Development Permit Panel

Re: Application by Omicron Architectural Engineering Construction Ltd. for a
General Compliance Ruling at 15111 Williams Road and Richmond Key 195105

Overlay Plan Showing The Existing And Proposed Pierson Road Alignment

Planting Strategy Plan

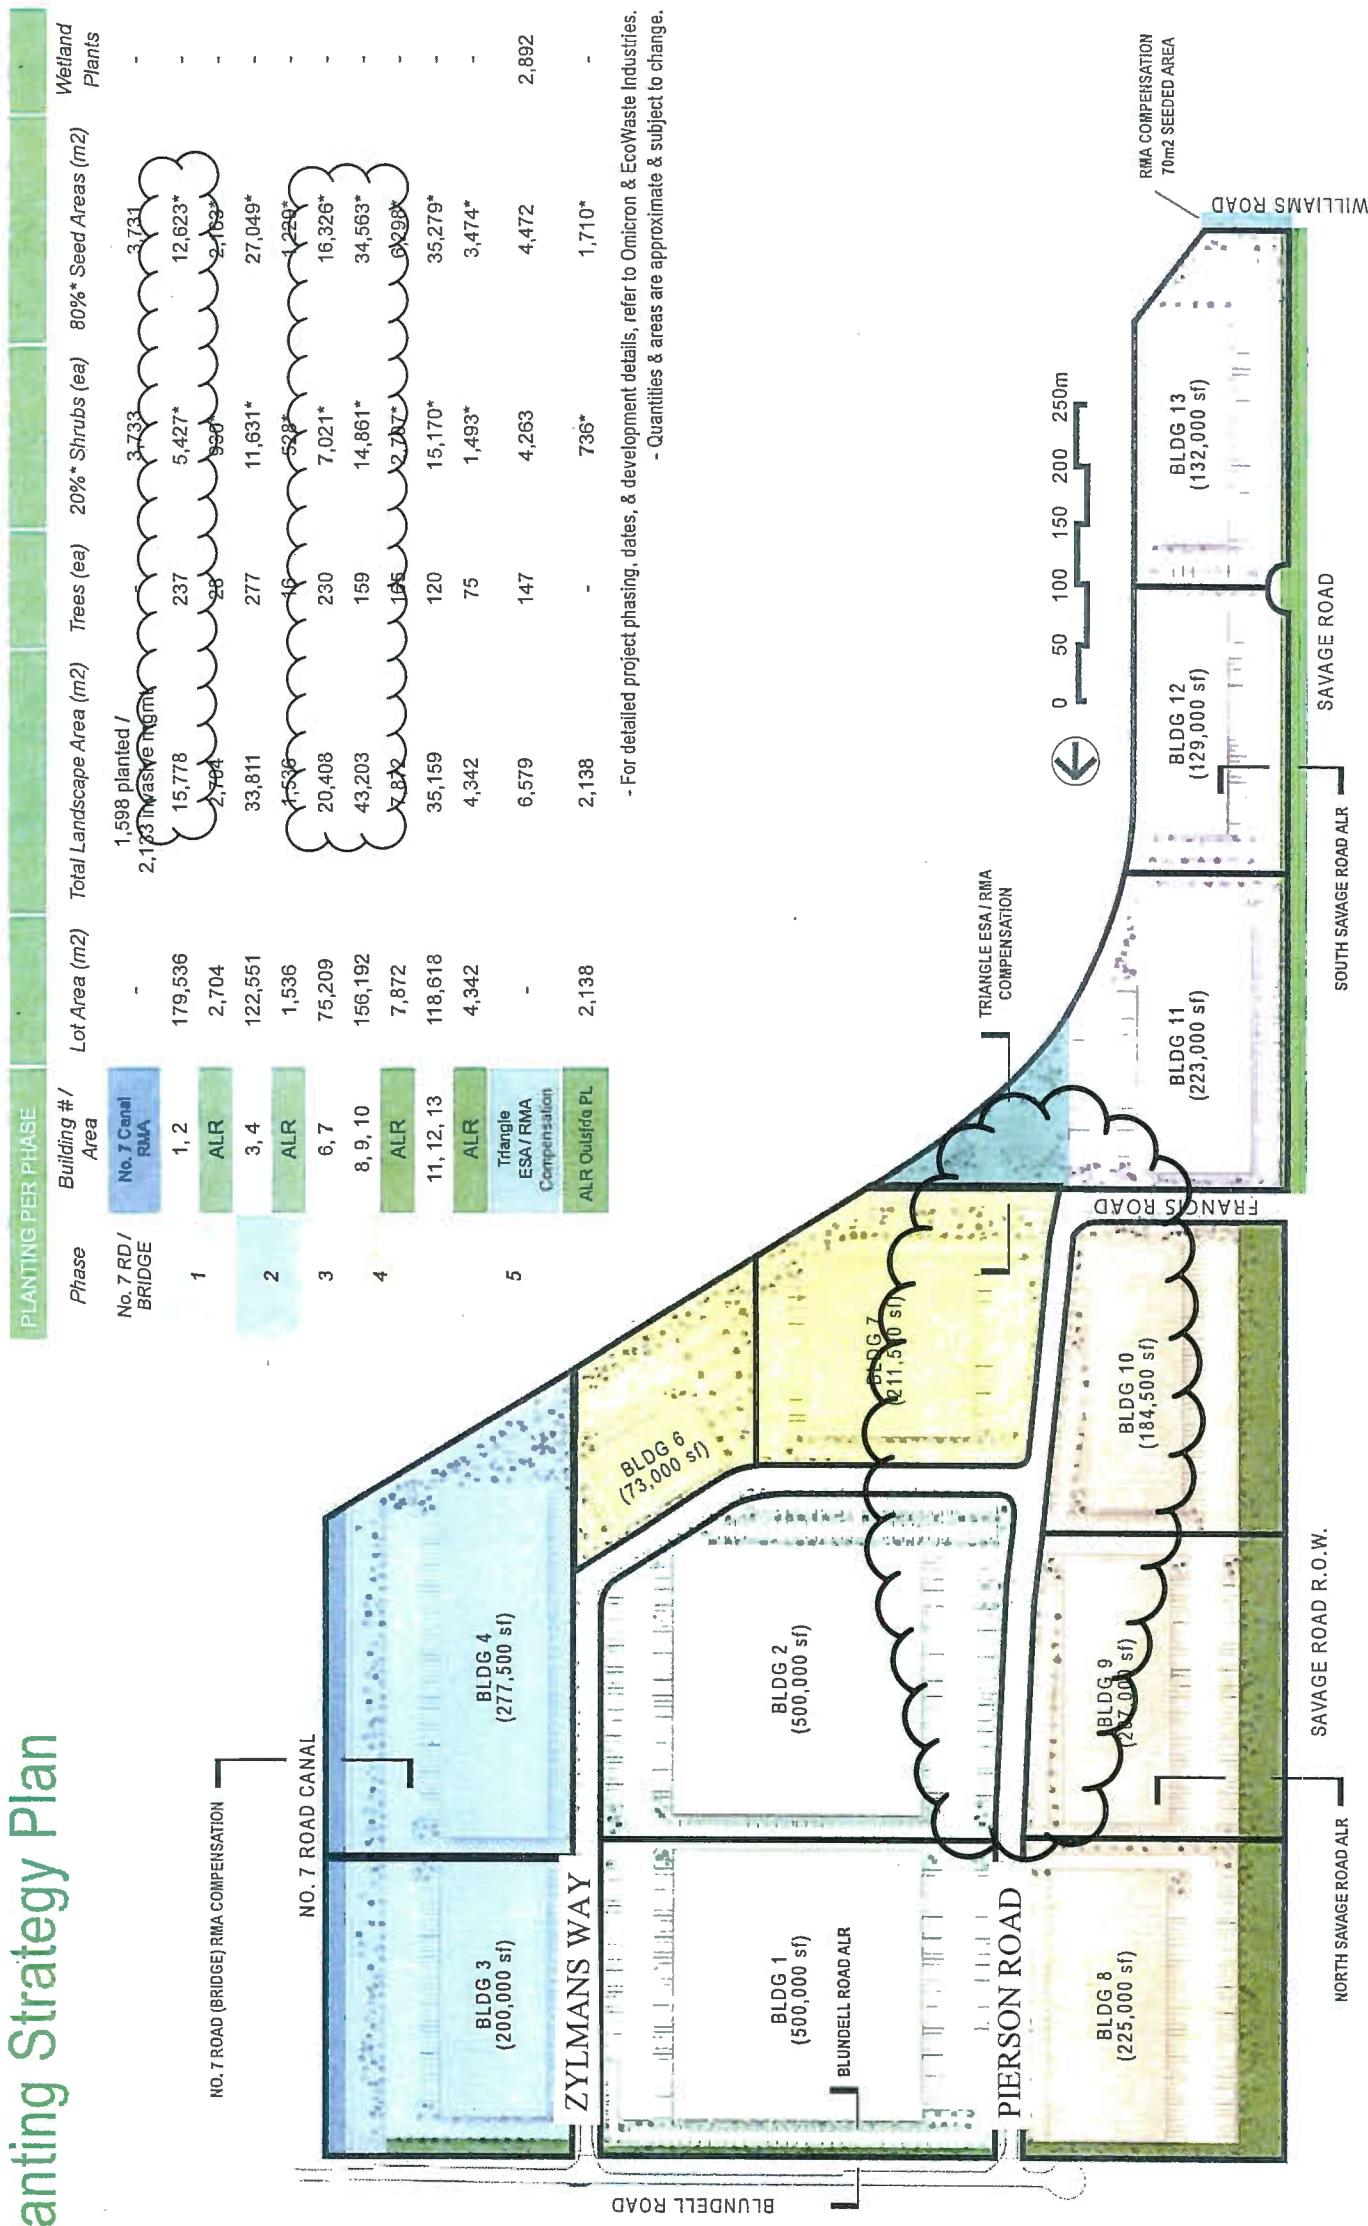
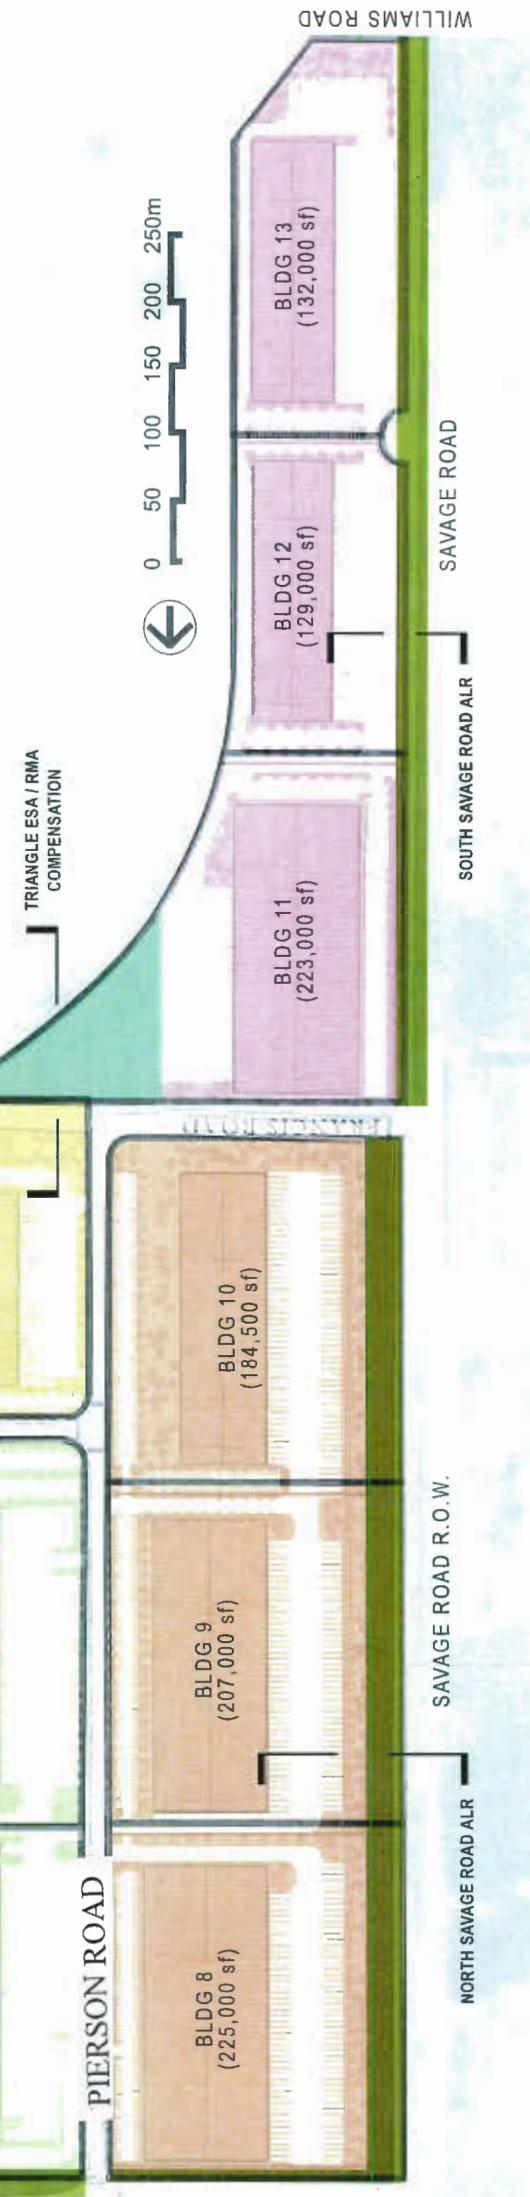
The proposed road/lease lot adjustments will result in a reconfiguration of the landscaping related to each on-site building application and landscaping along the Pierson Road street frontages as a result of the road realignment. Adjustments to the Pierson Road street frontages landscaping will be addressed via modified plan submissions as part of the Servicing Agreement(s).

On-site building related landscaping would be addressed with each Building Permit application and reviewed against the landscaping master plans approved as part of the original Development Permit (DP 11-566011). The proposed landscape revisions will result in an increase of 40 additional trees, 313 additional shrubs and 730 m² (7,858 ft²) more seeded areas over the originally approved Development Permit plans.

ROAD PHASING PLAN

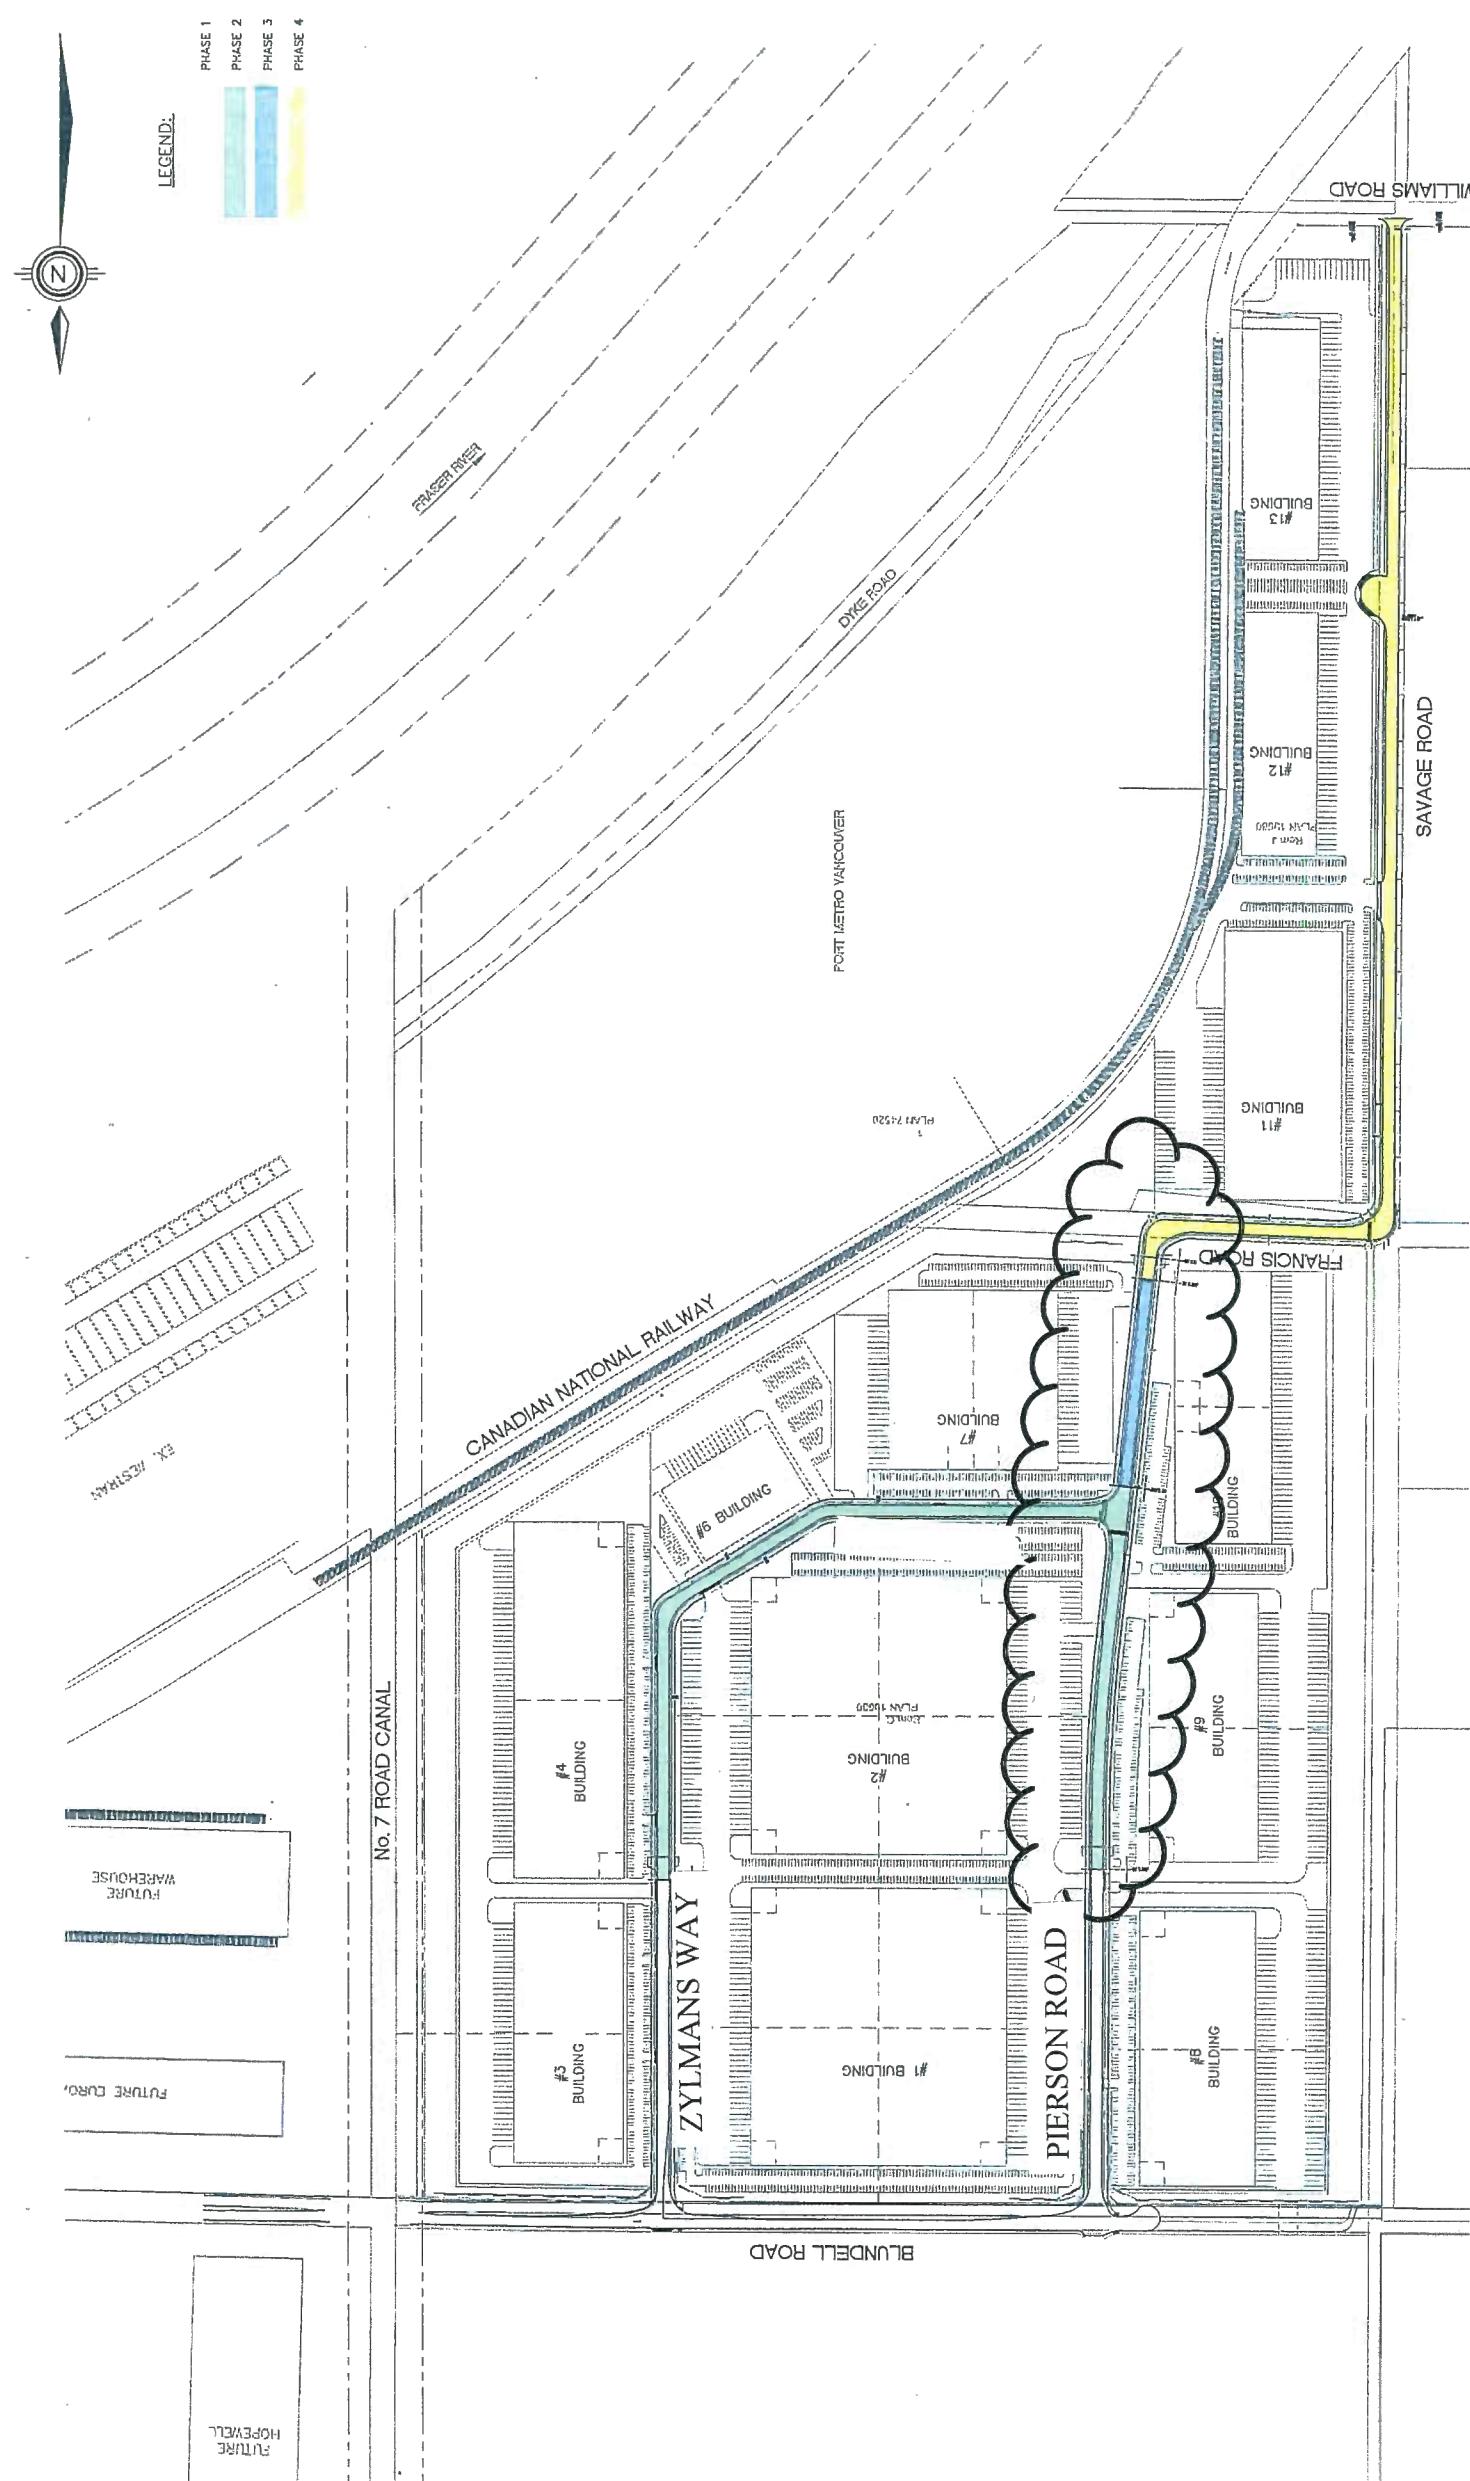
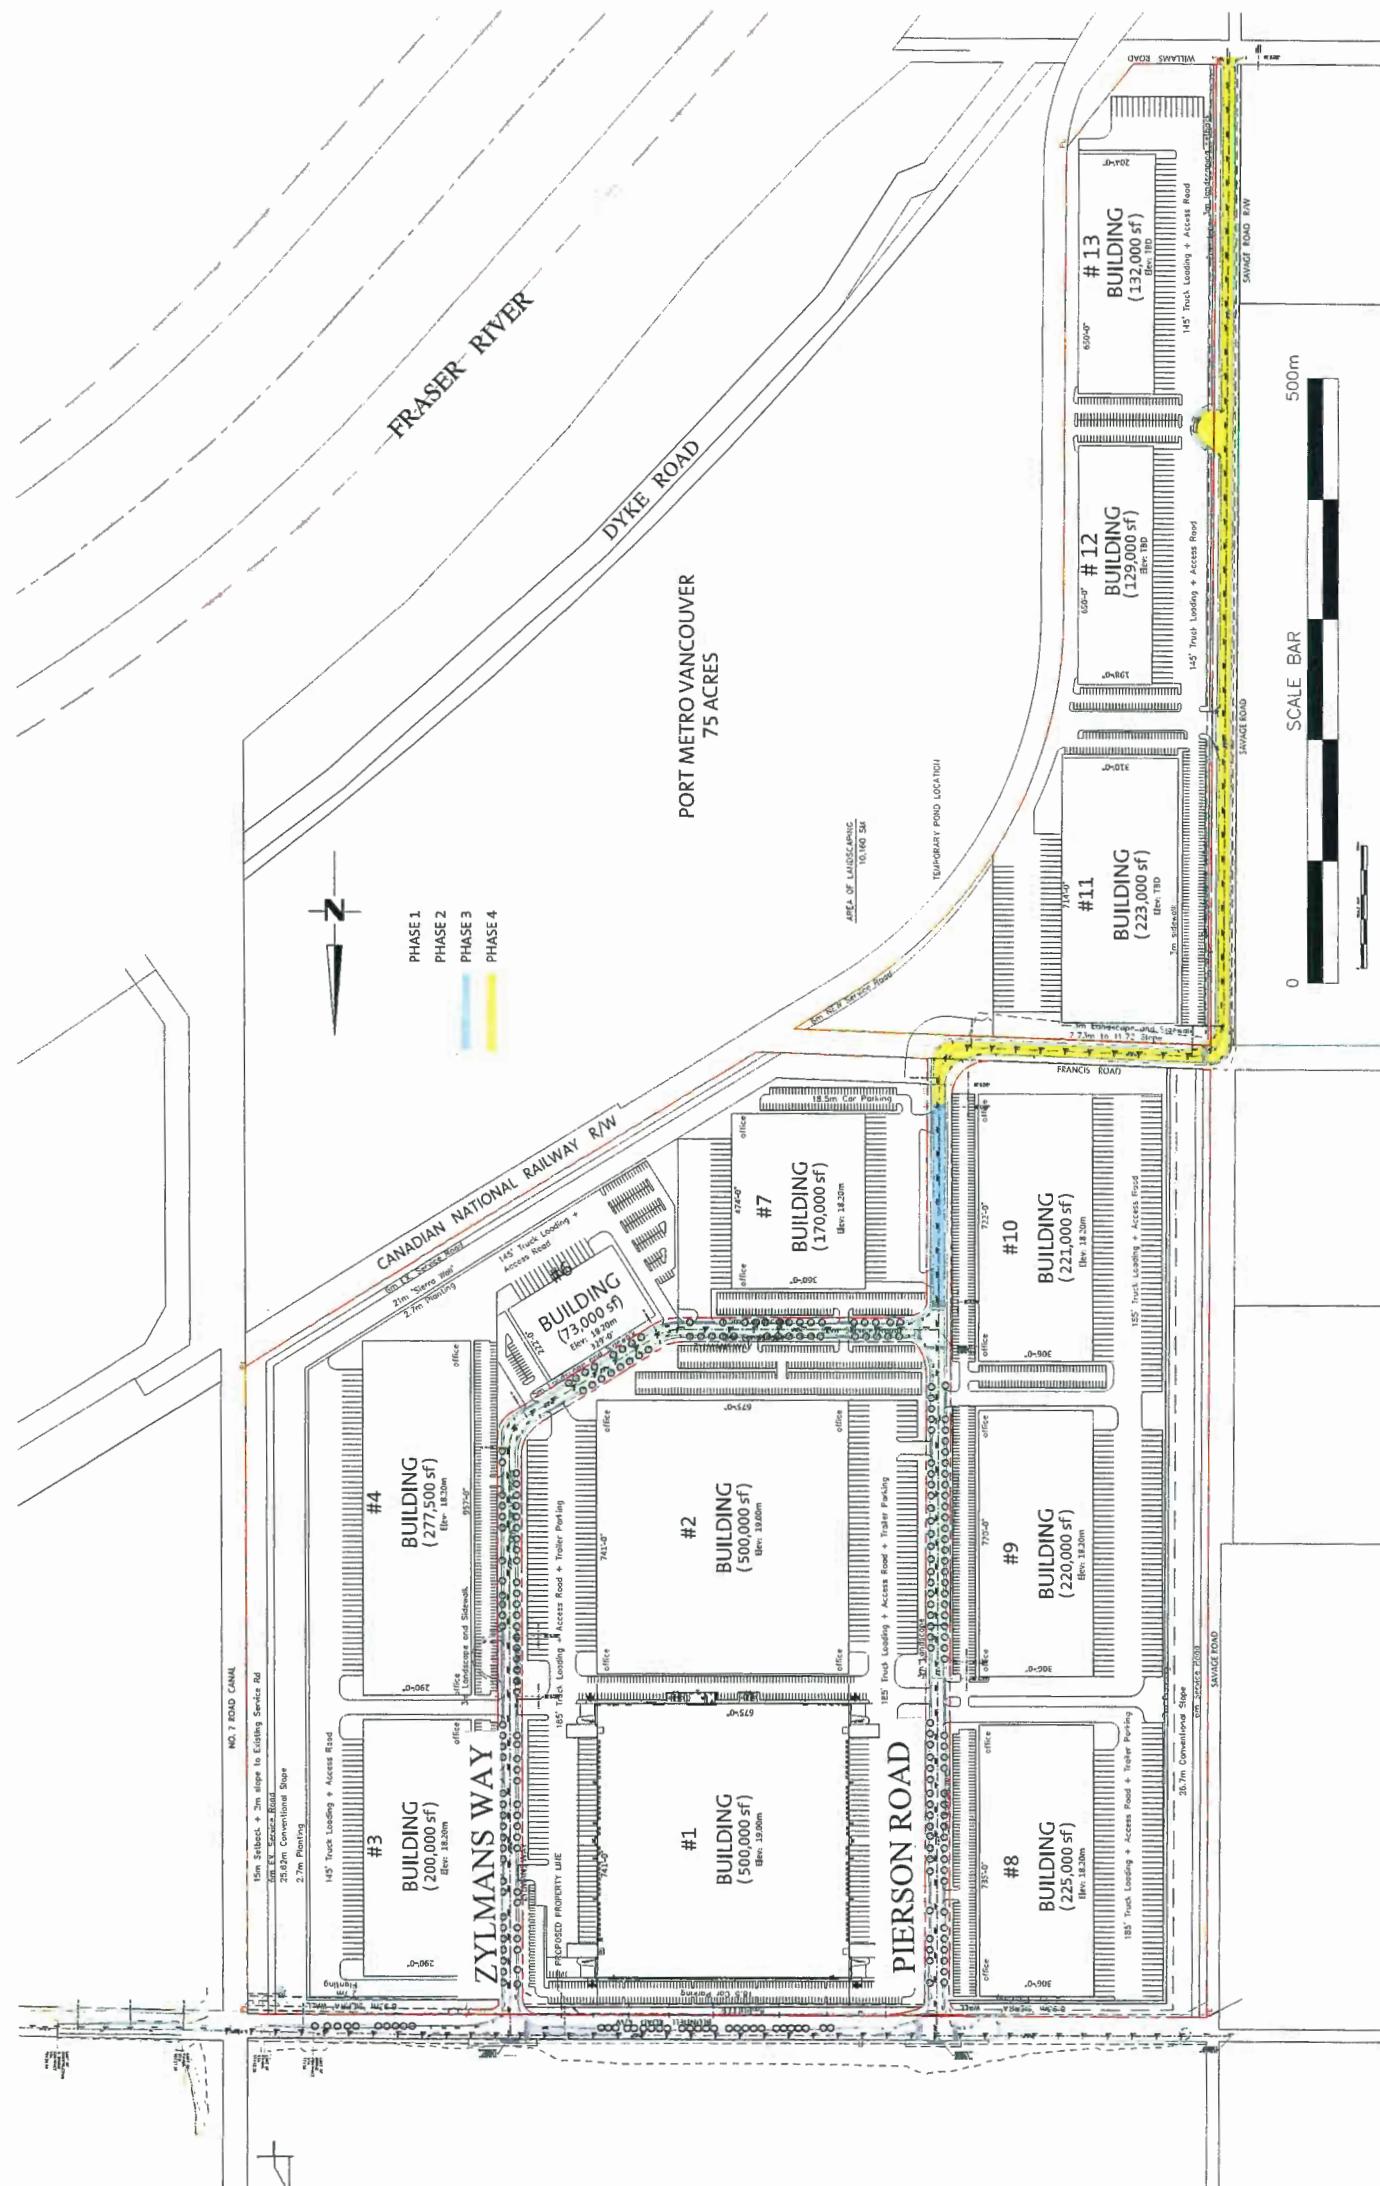
The proposed shifting of Pierson Road and the related filling within the Francis Road Right of Way will also affect the alignment of an emergency access route through the site that was required as part of the approved Development Permit (DP 11-566011).
